Project No. 12091-01

Subject: Preliminary Geotechnical Evaluation and Response to City Review Comments for Proposed San Pedro Distribution Center, 1599 W. John S. Gibson Boulevard, Los Angeles, California

5.0 RESPONSE TO CITY REVIEW COMMENTS

SHEET
3 of 5

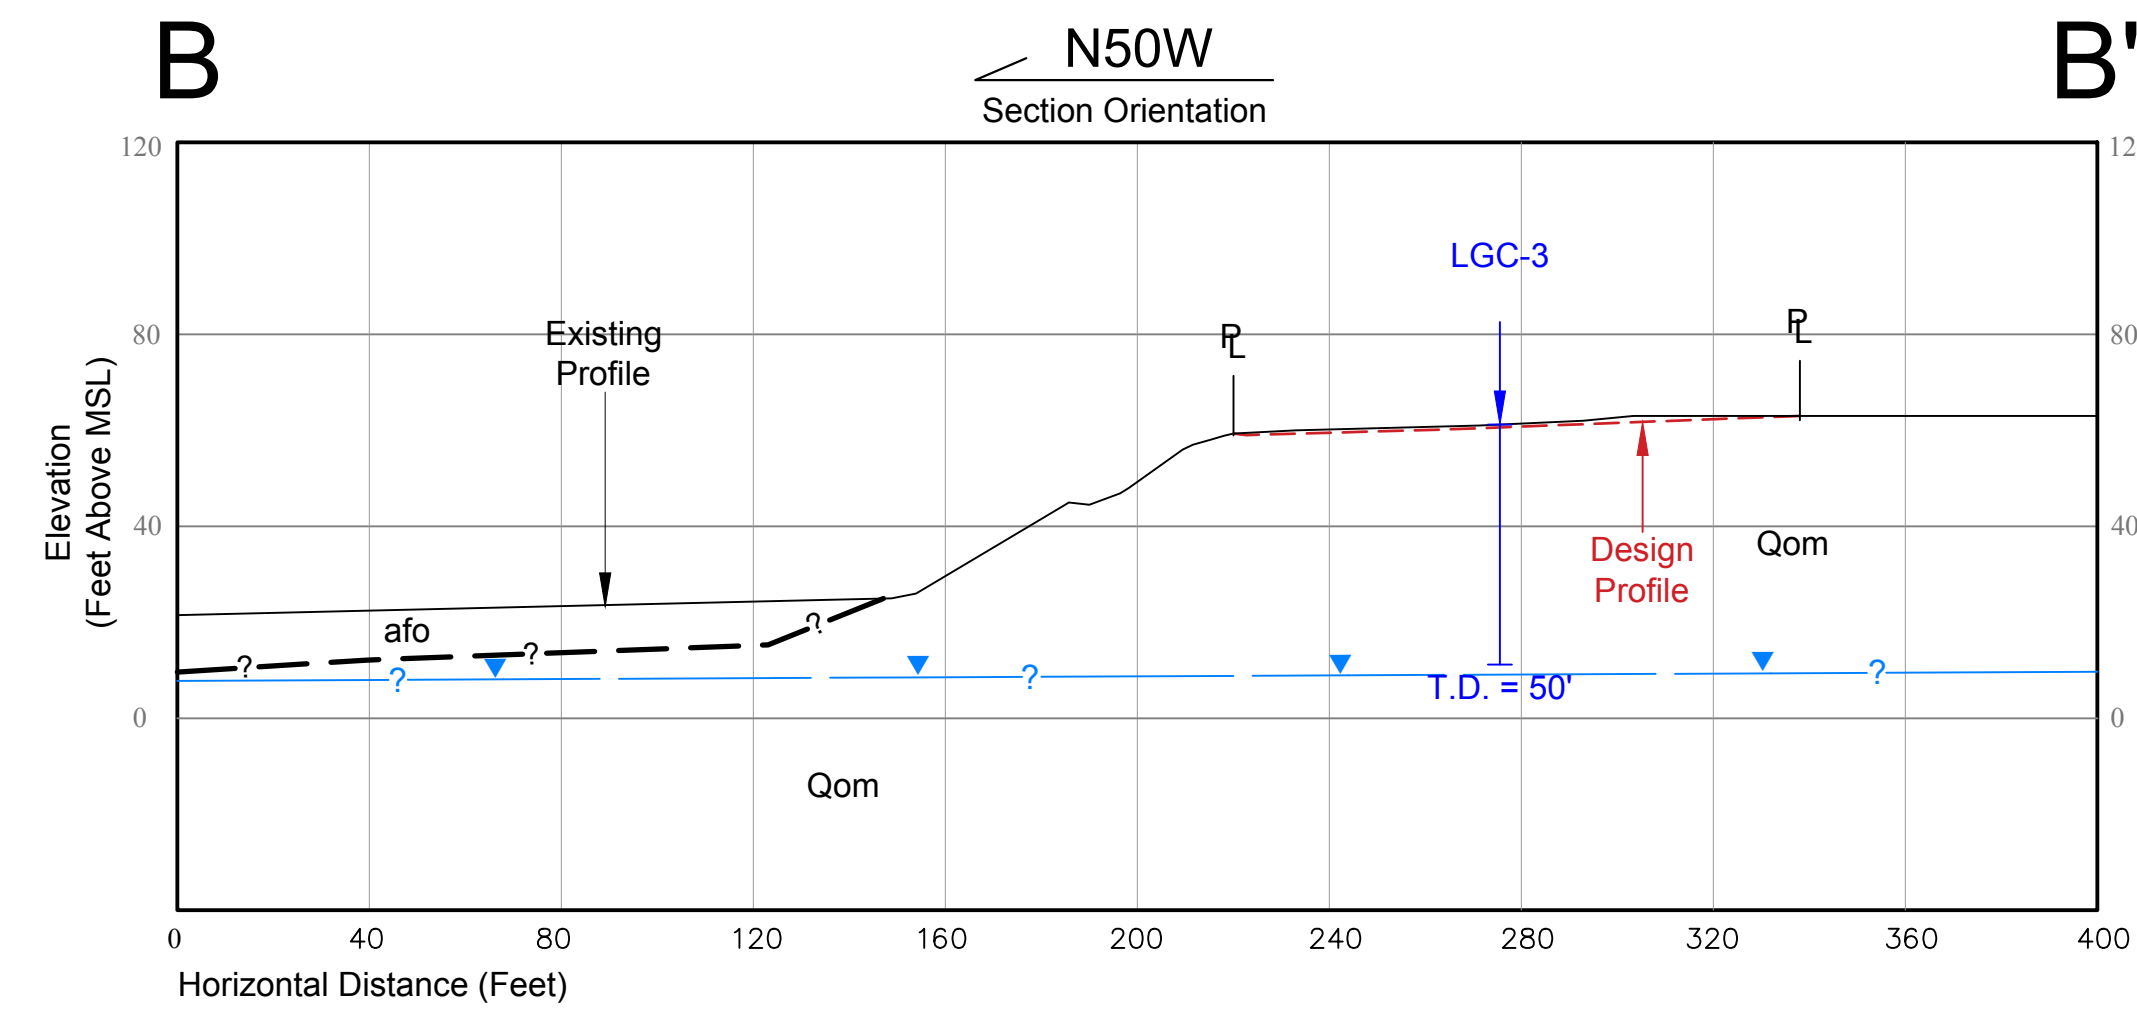
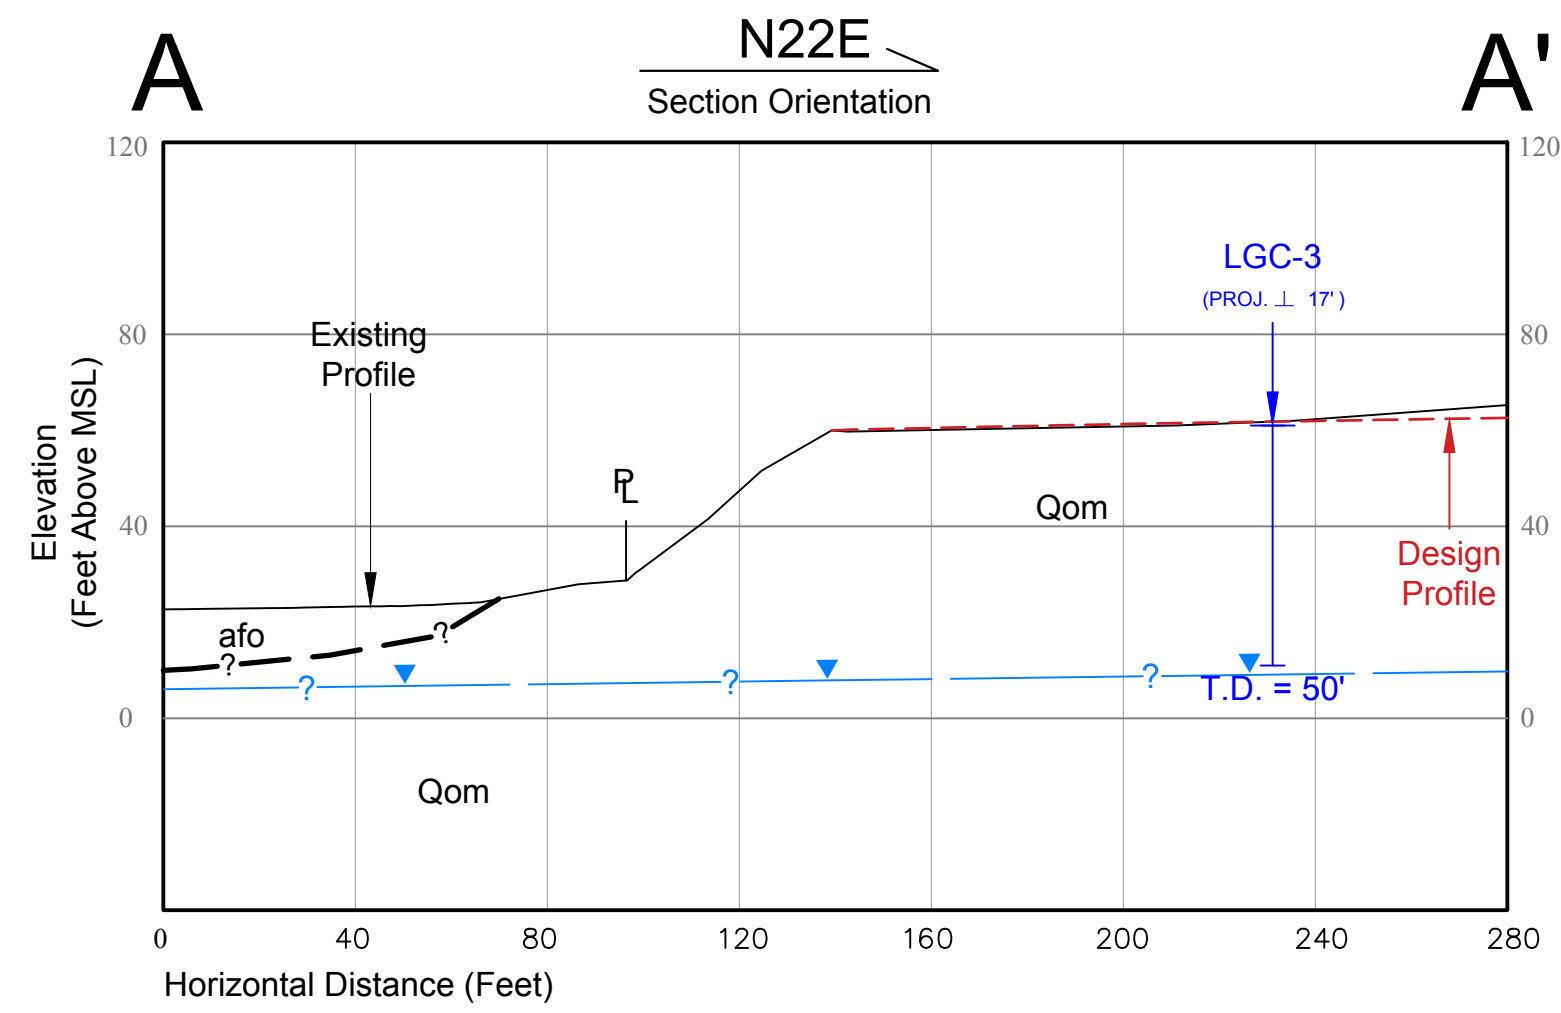
“Provide a geologic map and cross sections that are based upon conceptual grading or site development plans, to illustrate all proposed and existing contours relative to the planned grading and/or construction, along with all off-site slopes and conditions that could adversely affect the stability or safety of the site (7006.3.2). The geologic map and cross sections shall depict the top and bottom of slopes; lithologic contacts; bedding attitudes; locations of slumps, landslides, or faults relative to the subject site; existing and proposed topographic profiles; existing and proposed structures; and, required Code setbacks. (7006.3.2)”

“Provide geological cross sections illustrating existing and proposed grades and structures through the highest, steepest and geologically critical slopes.”

Refer to the attached Geotechnical Map and Geotechnical Cross Sections (Sheets 1 through 5). No building structures are planned for the site.
